SK#01
ONE page
ONE-Query
Date: 01-09-2026

FREDERICK CONFERENCE CENTER HOTEL

GARAGE LEVEL 1 PLAN - PART I

S102A

1 GARAGE LEVEL 1 PLAN - PART A
1/8" = 1'-0"

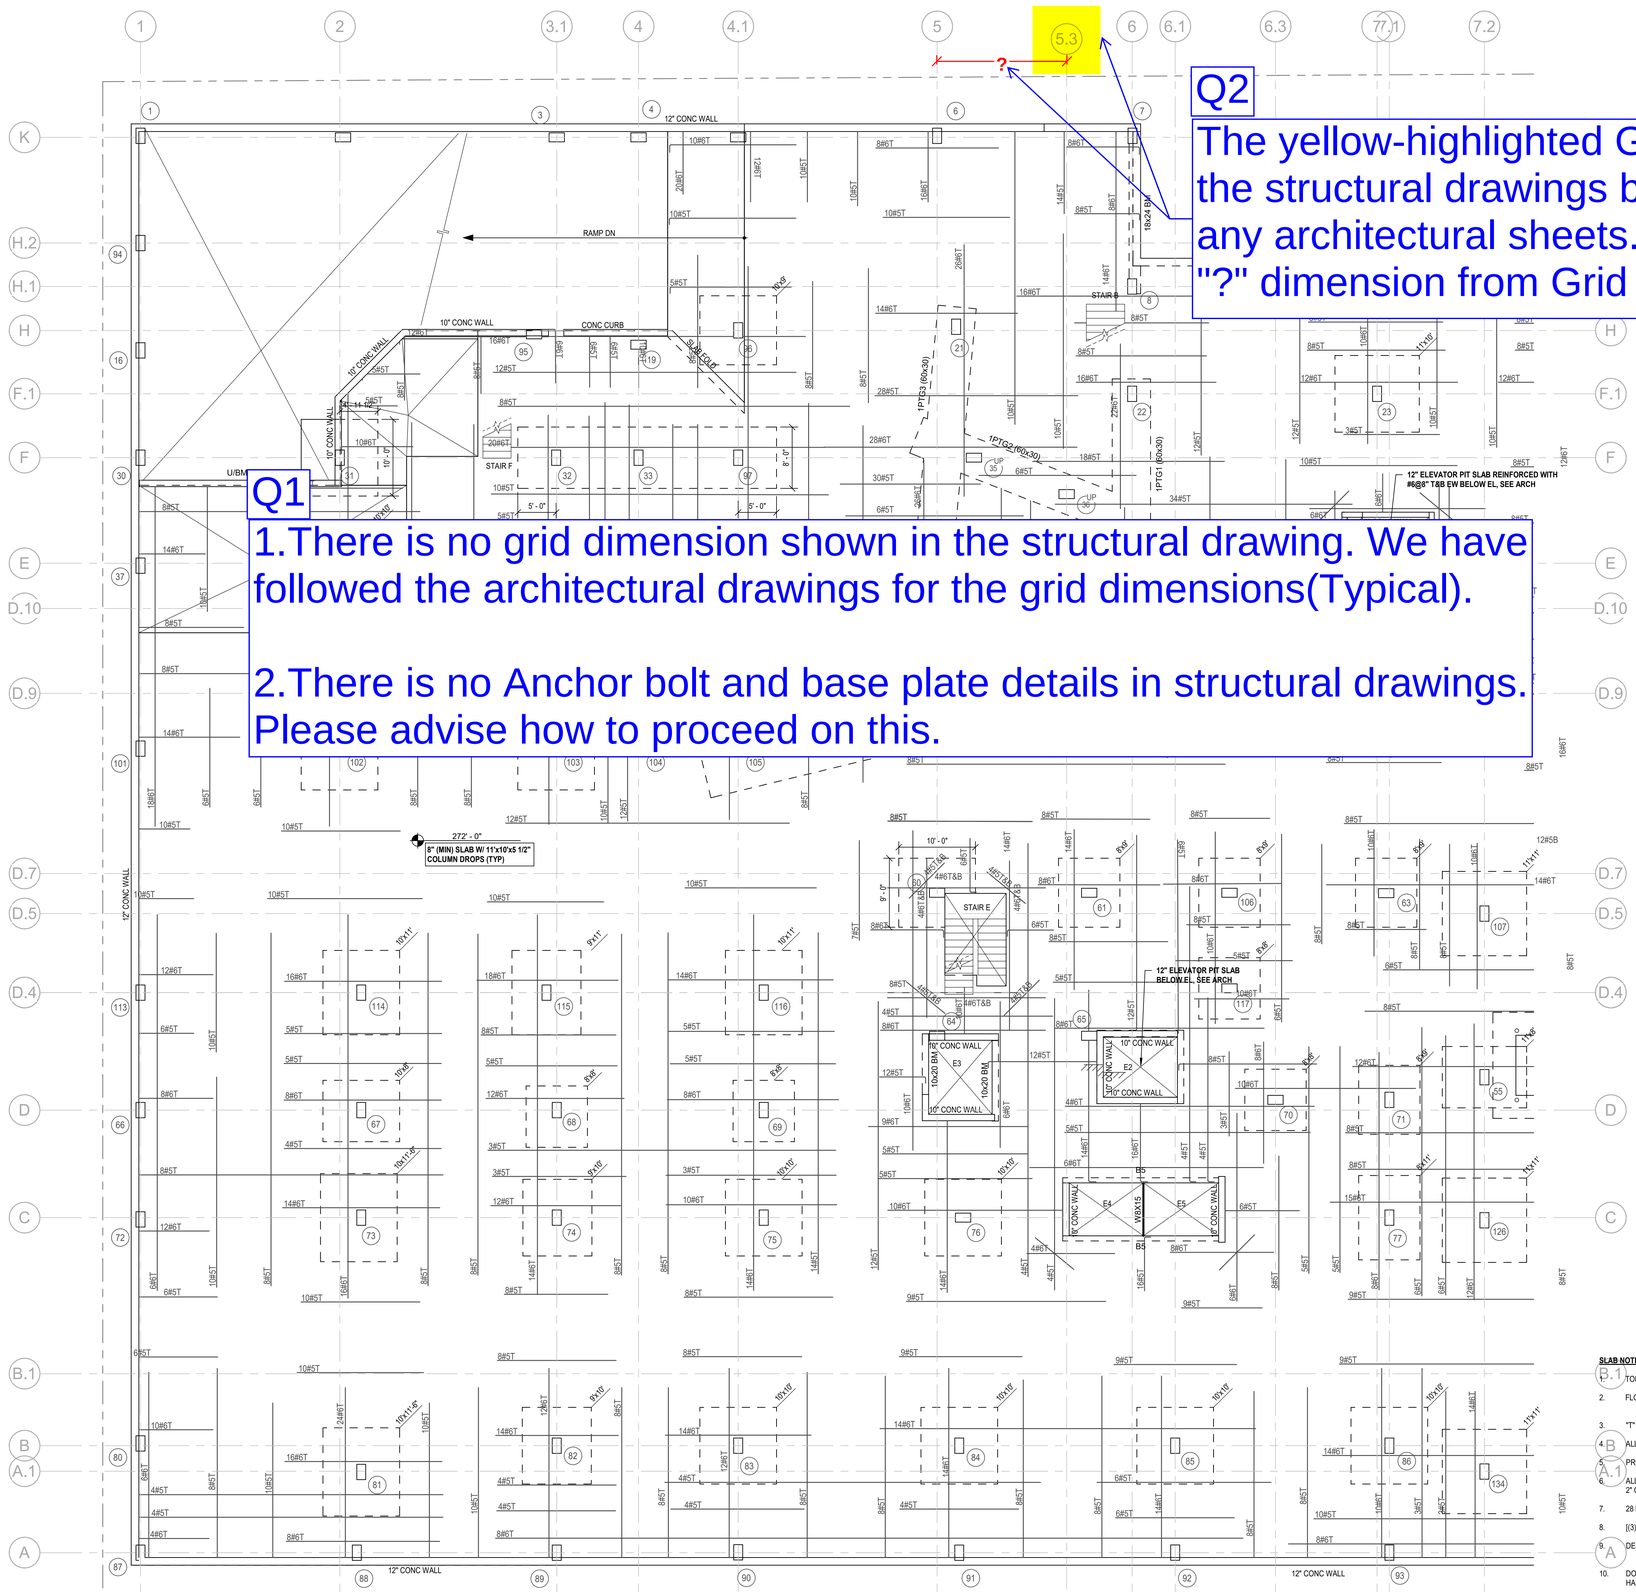
Q2

The yellow-highlighted Grid 5.3 is shown in the structural drawings but not shown on any architectural sheets. Please provide the "?" dimension from Grid “5. to grid 5.3”

Q1

1.There is no grid dimension shown in the structural drawing. We have followed the architectural drawings for the grid dimensions(Typical).

2.There is no Anchor bolt and base plate details in structural drawings. Please advise how to proceed on this.
